Table of Contents

SUP25-09-04.....214 Girod

CASE SUMMARY: Change the driveway and parking lot from limestone to concrete

A1.0

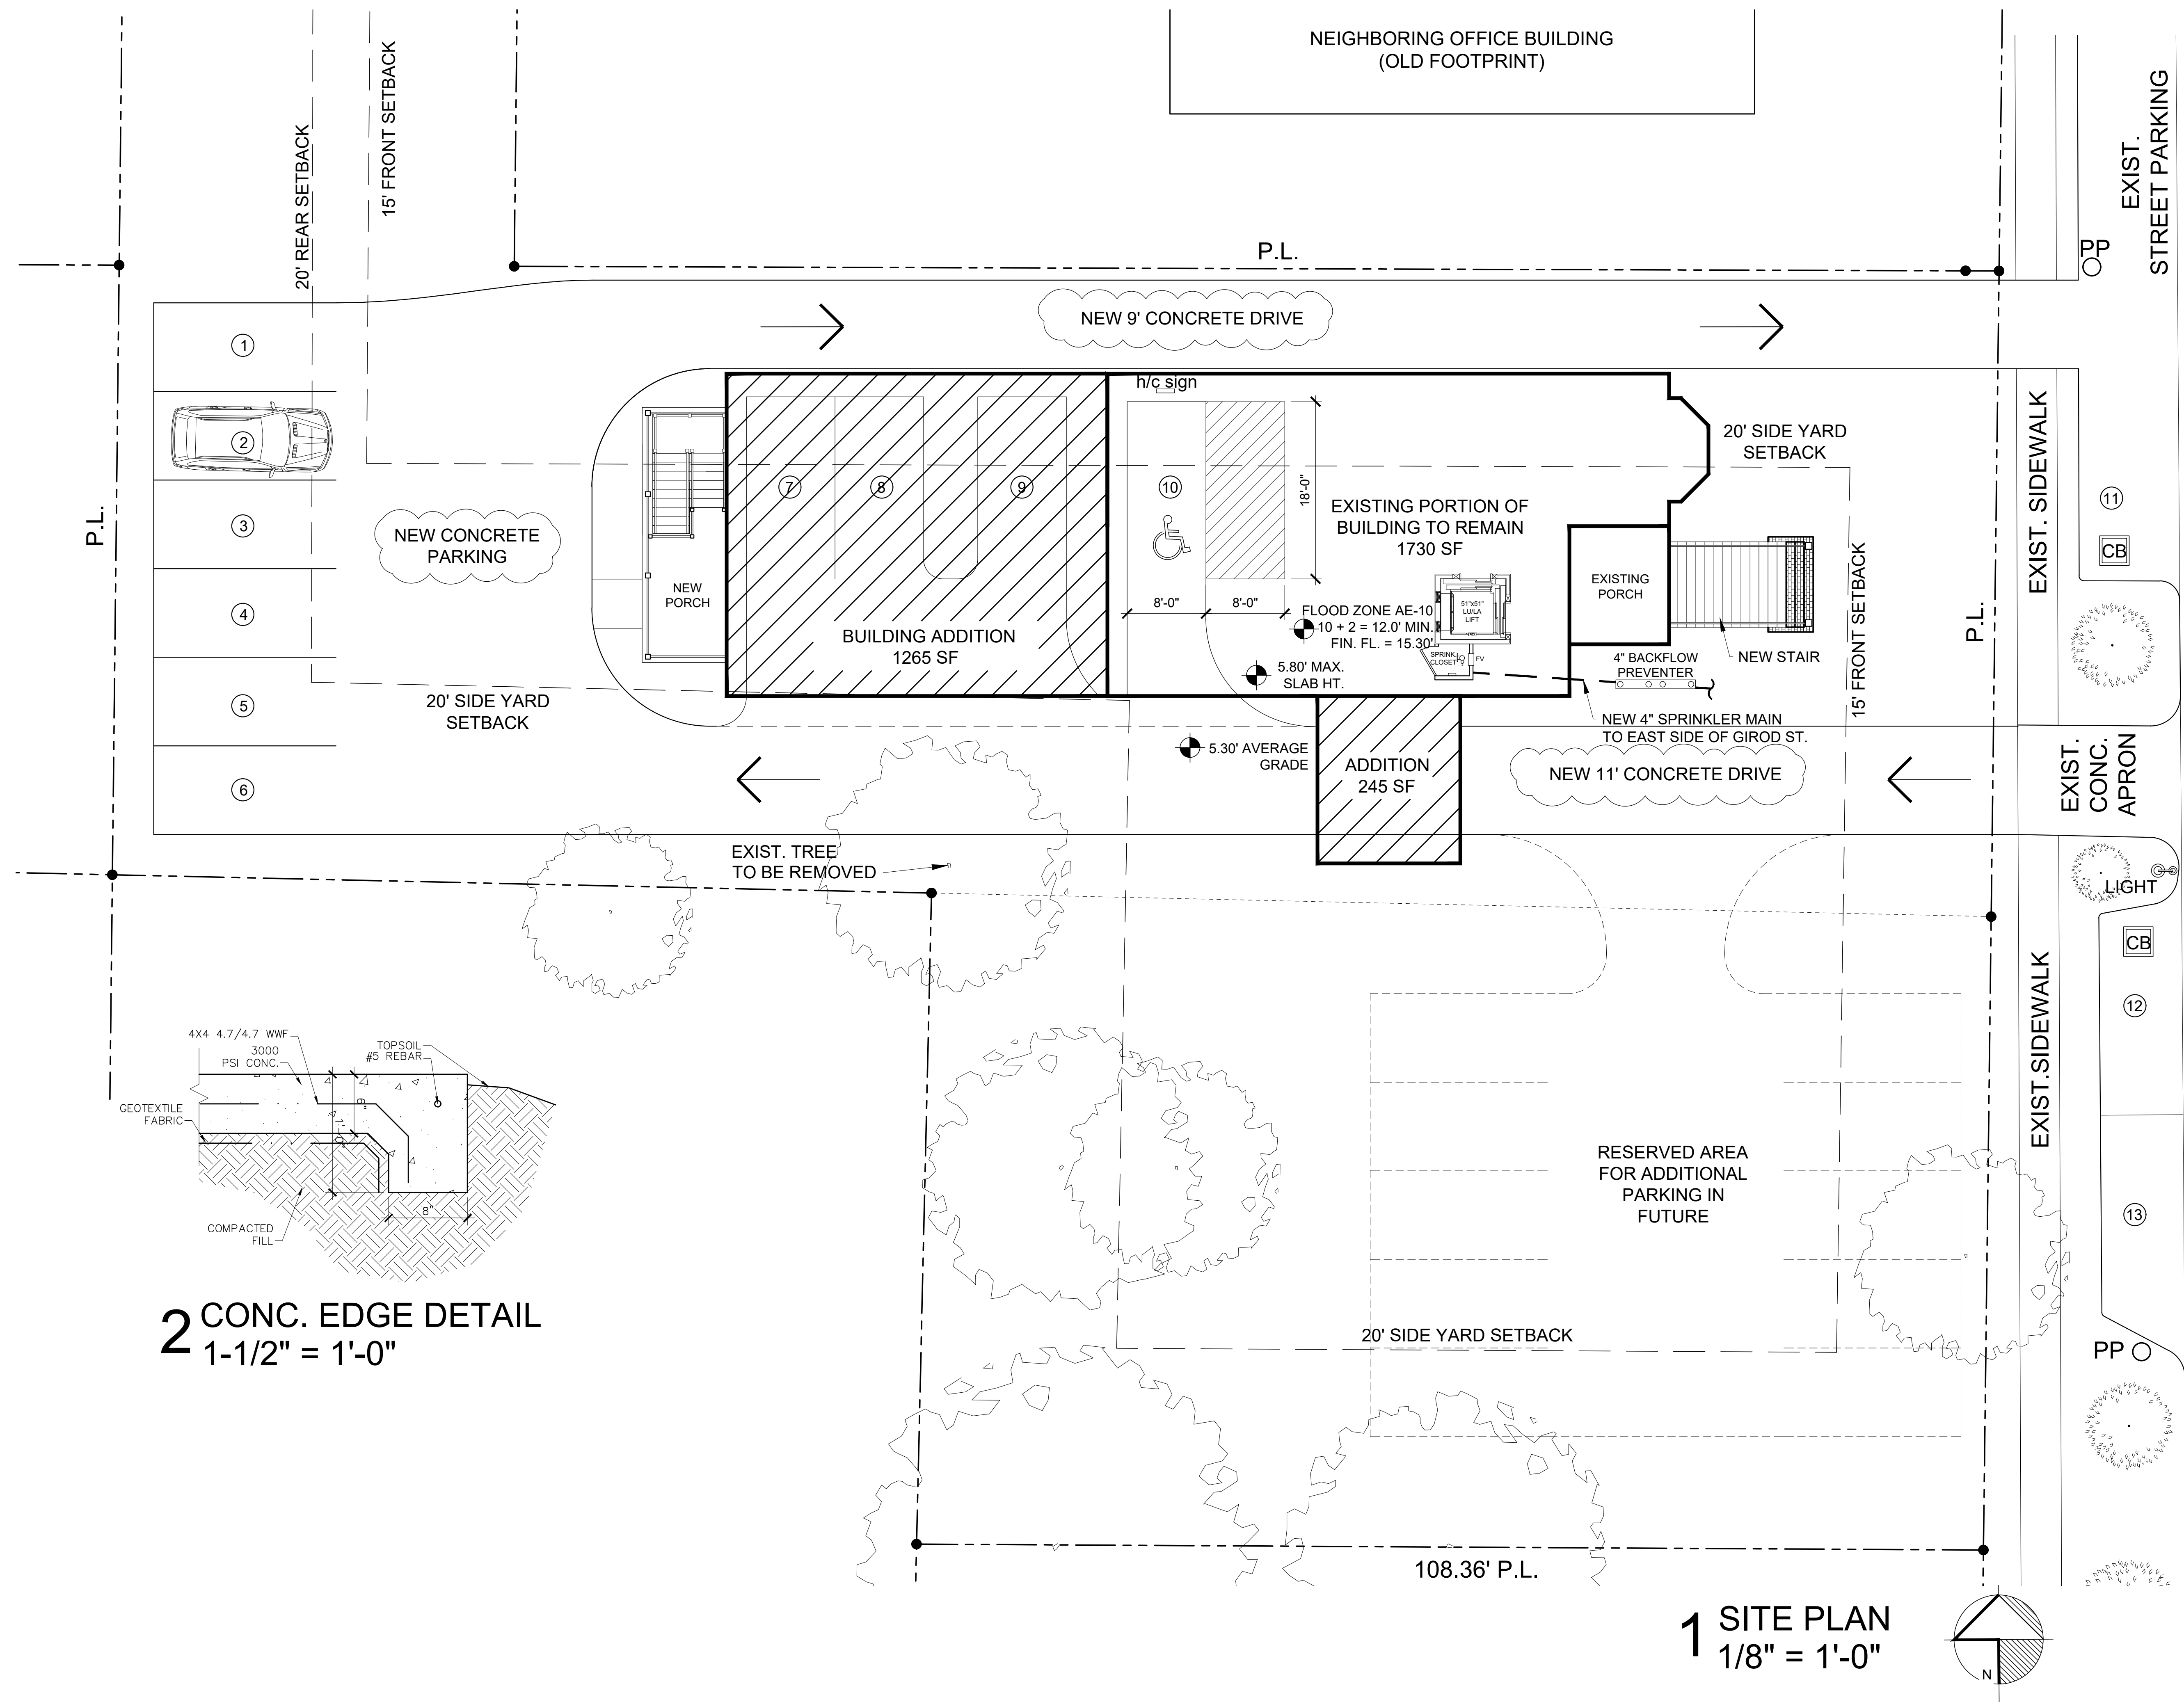
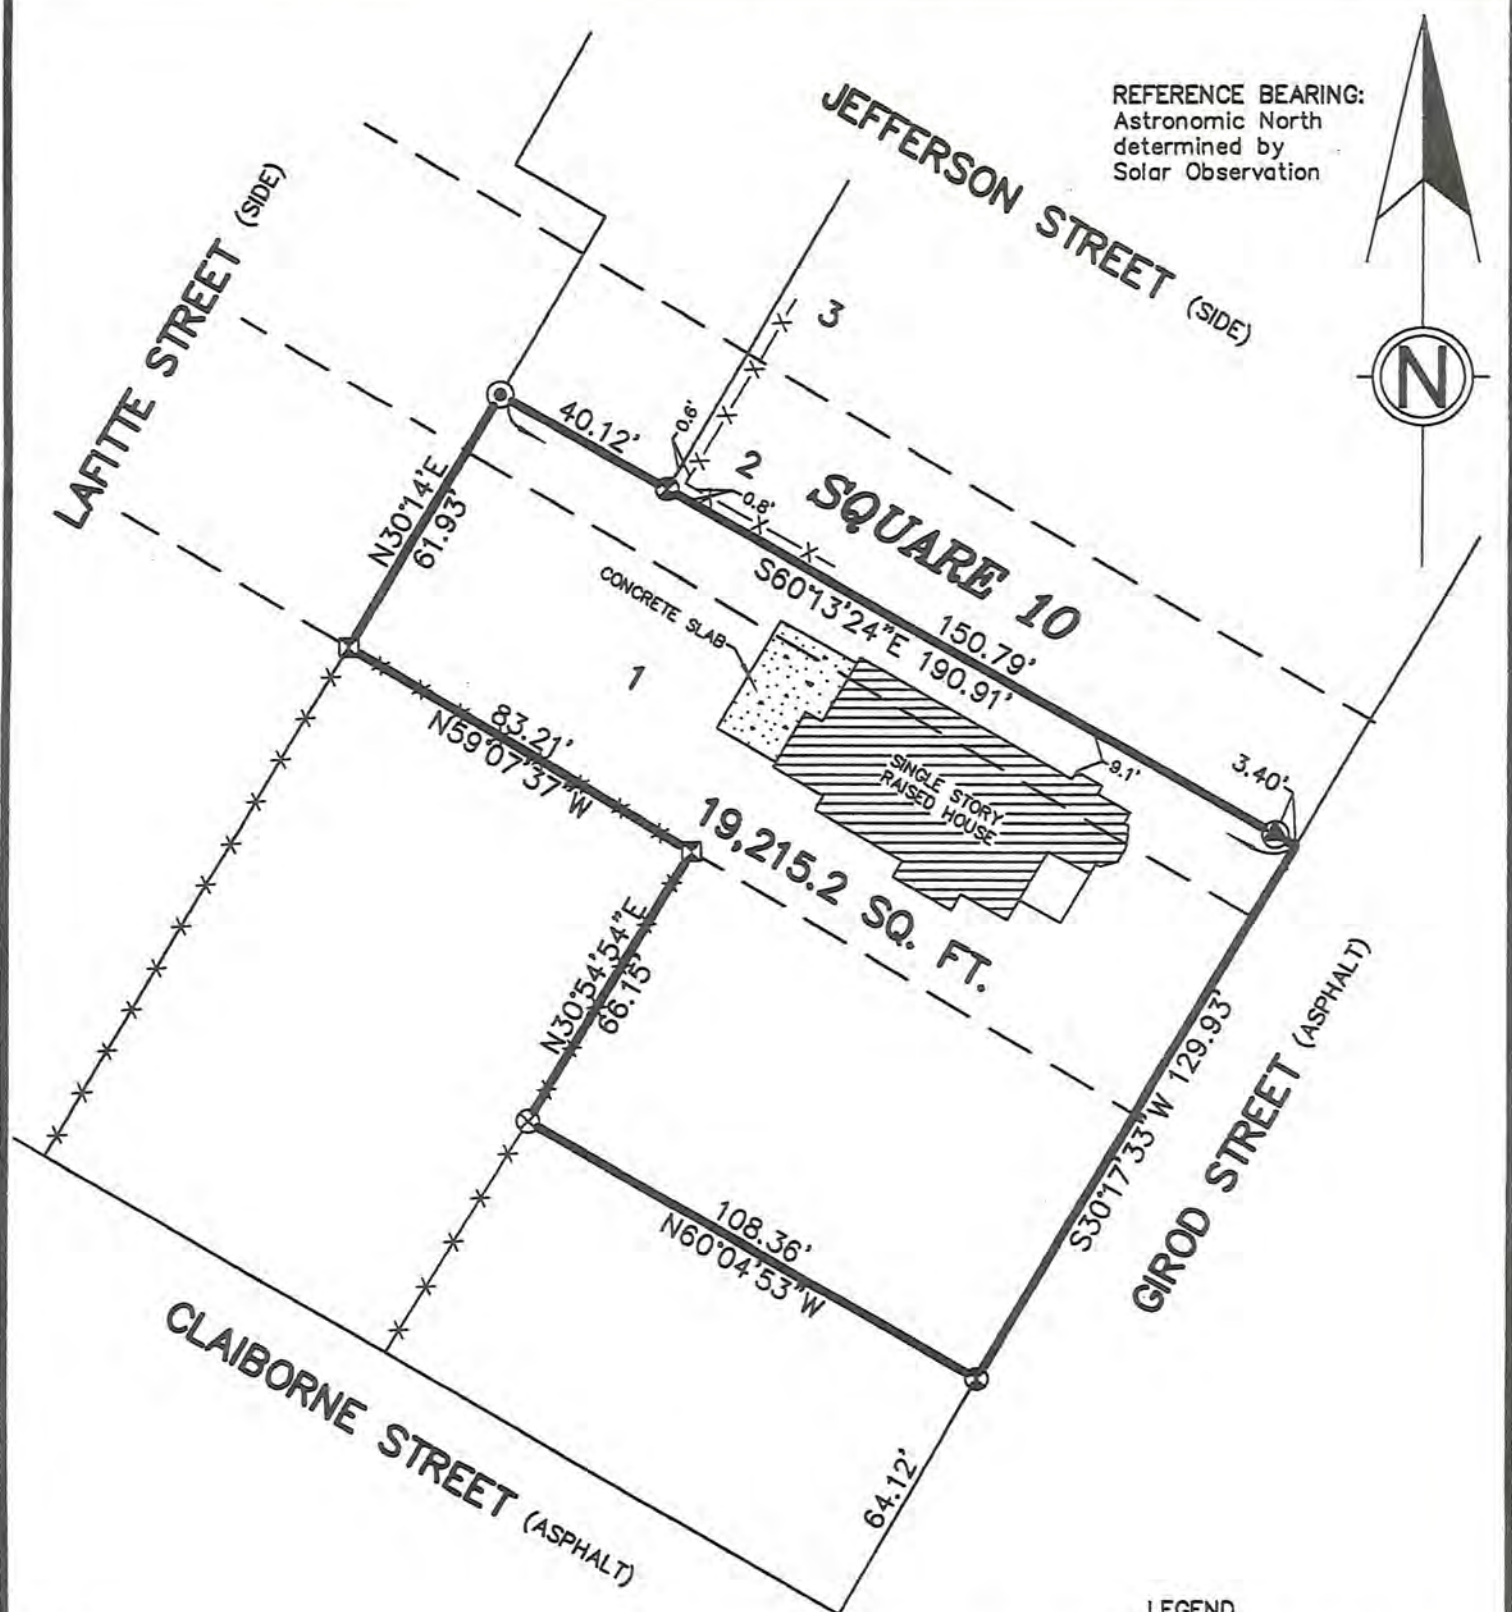
A permit to renovate the existing structure on the property into a new oral surgery center was issued in February 2024. As part of the approved site plan a limestone driveway and parking area were proposed. The owner is now requesting to change the limestone to concrete in order to meet ADA requirements. The application included the following statement: *“To meet ADA requirements, we are requesting to be heard to change the limestone requirements to concrete in the driveway and parking areas. Patients leaving the office after sedation will not be able to navigate the terrain of limestone”.*

The City Engineer has reviewed the proposed changes and stated that *“If the concrete pavement is granted then a new drainage study and drainage plan will be required to be submitted and reviewed since the surface runoff will increase due to the change of surface condition”.*
